Deputation to Vaughan City Council
July 13, 2020
Agenda Item #4
OP.20.001
Salz Corporation

COMMUNICATION - C95
CW (PH) - July 13, 2020
ITEM # 4

Appendix 1 - Green Space Shortages

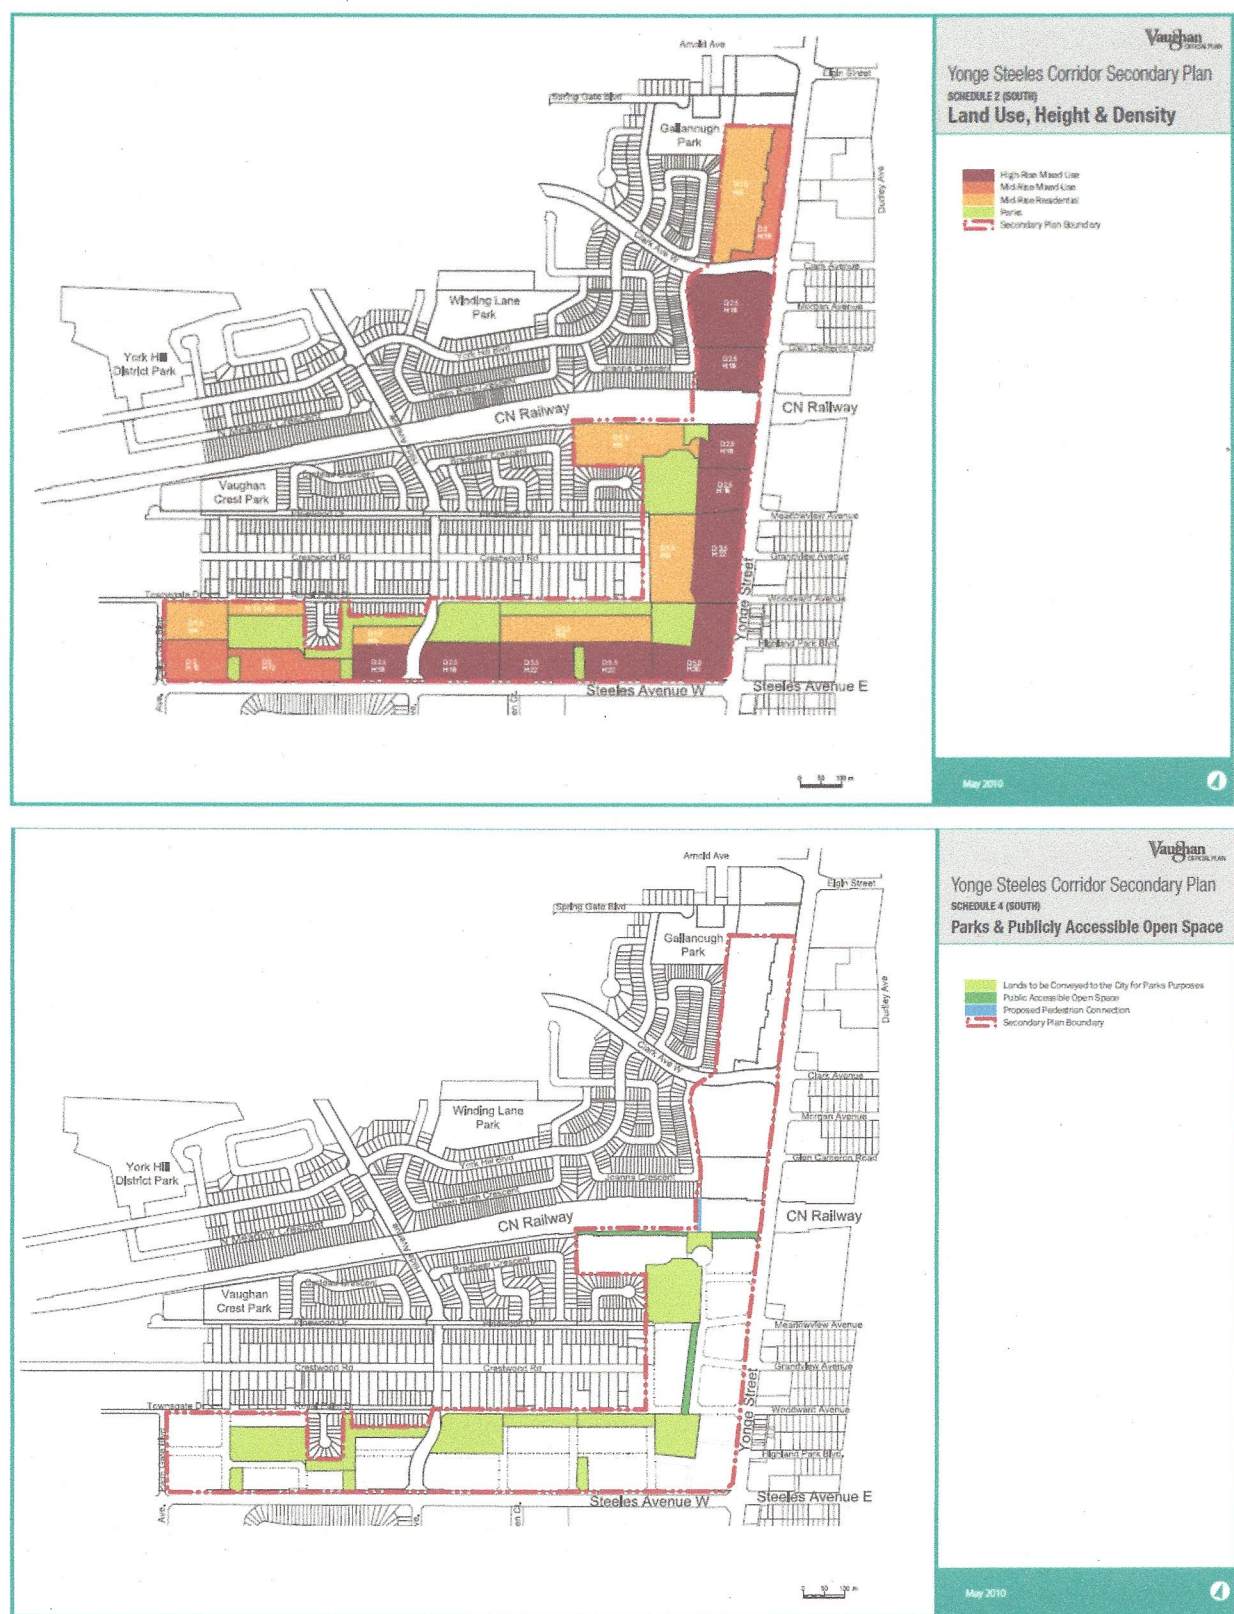
As can be seen in Schedules 2 and 4 below (marked in green), the Secondary Plan incorporated a significant portion of land in the area to serve as a green "buffer" and connector transition

between low-rise residential and the mid-rise residential properties. In particular, we note the designation of a linear park of roughly a 50-foot width on the southern side of the Royal Palm Drive Extension from Hilda to the southern extension of Powell Road.

Figure 1: Salz Block Layout (Planning Rationale Report, p. 17)

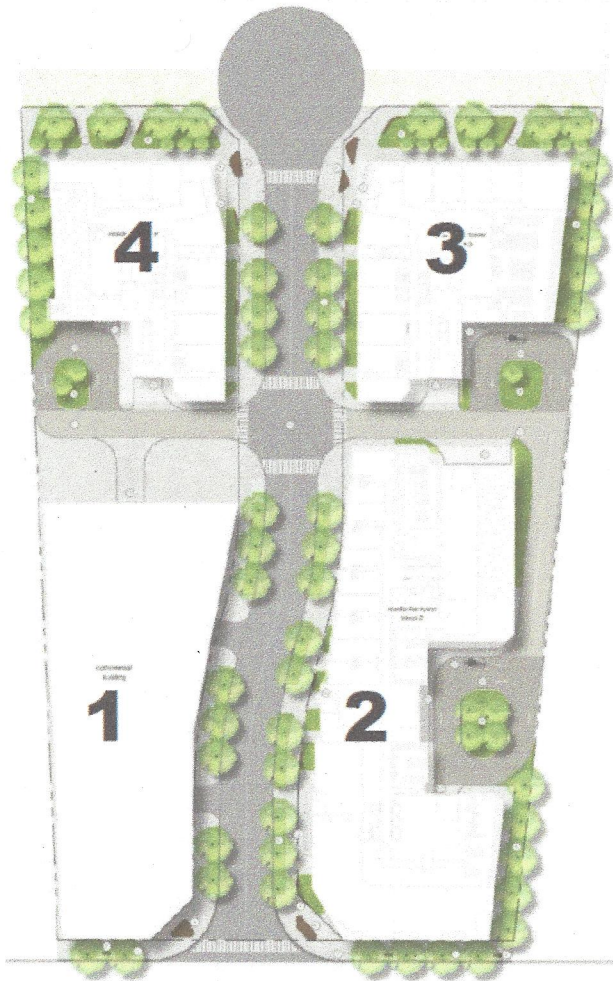
It is therefore both surprising and glaring that the Salz (Figure 1) proposal includes only a small strip of trees (two and one row, respectively) on the south side of Royal Palm for any green space, despite the very deep lot of 100 Steeles Ave West. They have instead provided podium rooftop “amenities” for the exclusive use of the building residences, but inaccessible and therefore prohibited to nearby established residences.

Salz Corporation has not provided any land for public park, and any green or open space amenities and landscaping (aside from a small row of trees on the north end of the property) are all contained within and for the exclusive benefit of the new buildings. The small north-south green strip indicated on Schedules 2 and 4 is not incorporated into the 100 Steeles Ave West proposal. These omissions were frequently identified in the May 28, 2020 Design Review Panels for this project.

This omission of a linear park system is a missed opportunity for a significant green “ribbon” with potential amenities such as bike paths, water fountains/splash pads, sculptures, benches, playgrounds, gazebos, etc. We urge the Salz Corporation to reconsider their plans and design for a vibrant and substantial green ribbon linear park as envisioned and required by the Yonge-Steeles Corridor Secondary Plan.
